TURKEY POINT NUCLEAR GENERATING UNIT NO. 3

TURKEY POINT NUCLEAR GENERATING UNIT NO. 4

AMENDMENT NO. 54 TO FACILITY OPERATING LICENSE NO. DPR-31

SAFETY EVALUATION BY THE OFFICE OF NUCLEAR REACTOR REGULATION
RELATED TO AMENDMENT NO. 54 TO FACILITY OPERATING LICENSE NO. DPR-31
AND AMENDMENT NO. 46 TO FACILITY OPERATING LICENSE NO. DPR-41
FLORIDA POWER AND LIGHT COMPANY
TURKEY POINT NUCLEAR GENERATING, UNIT NOS. 3 AND 4
DOCKET NOS. 50-250 AND 50-251

Figure 3.2-3a

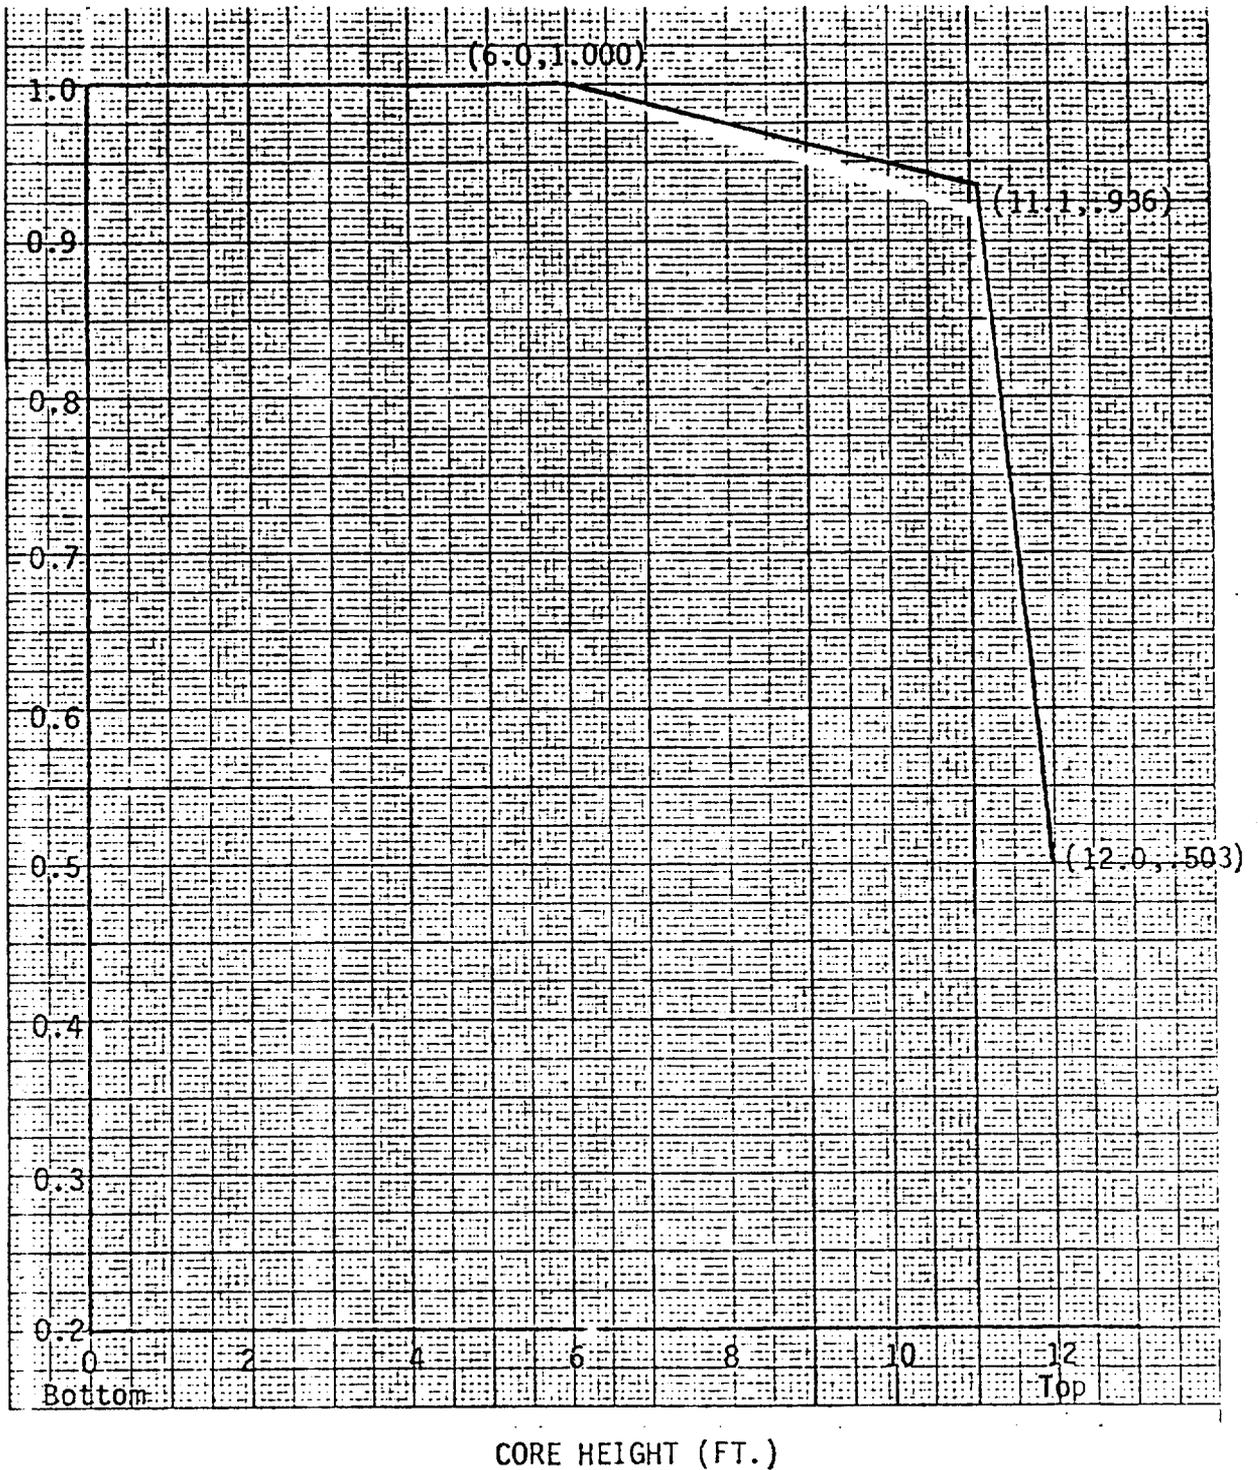
- (a) change of F_0 to 1.99 for plant operation with 22% or less of the steam generator tubes plugged.
- (b) change of the Hot Channel Factor Normalized Operating Envelope for a steam generator tube plugging limit of 22% (Figure 3.2-3a).
- (c) deletion of the Hot Channel Factor Normalized Operating Envelope for steam generator tube plugging levels between 15% and 19% (Figure 3.2-3).

HOT CHANNEL FACTOR
NORMALIZED OPERATING ENVELOPE

(for steam generator tube plugging 22% and $F_q = 1.99$)

FIGURE 3.2-3b

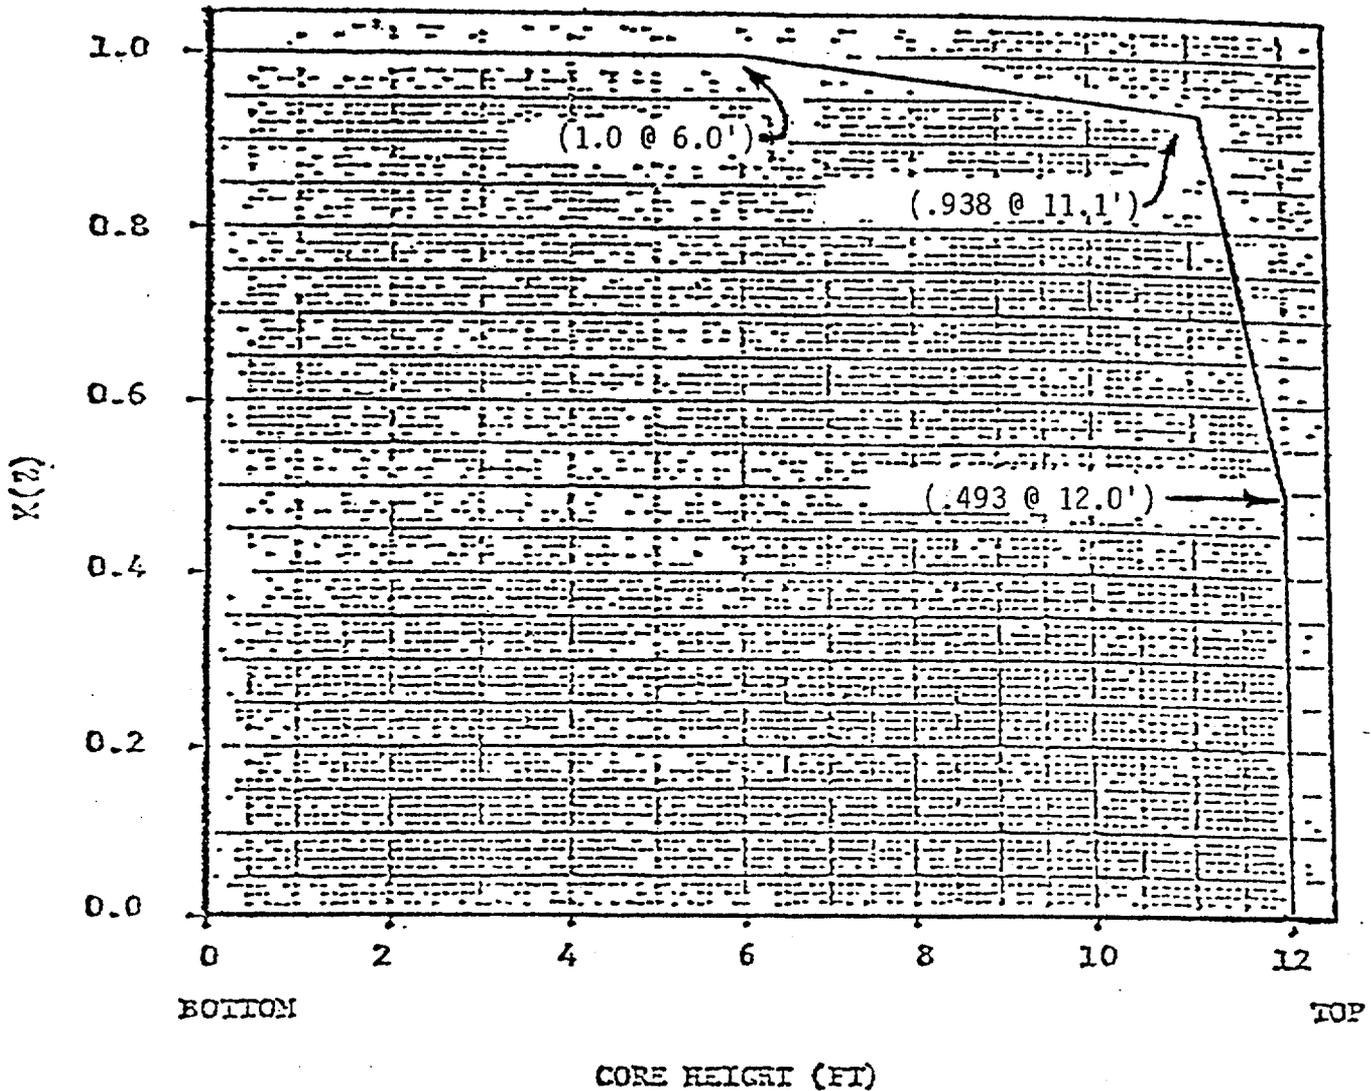
HOT CHANNEL FACTOR-NORMALIZED
 OPERATING ENVELOPE (FOR STEAM
 GENERATOR TUBE PLUGGING $\leq 25\%$ and $F_q = *$)

* To be supplied based on results of revised ECCS analysis for 25% steam generator tube plugging.
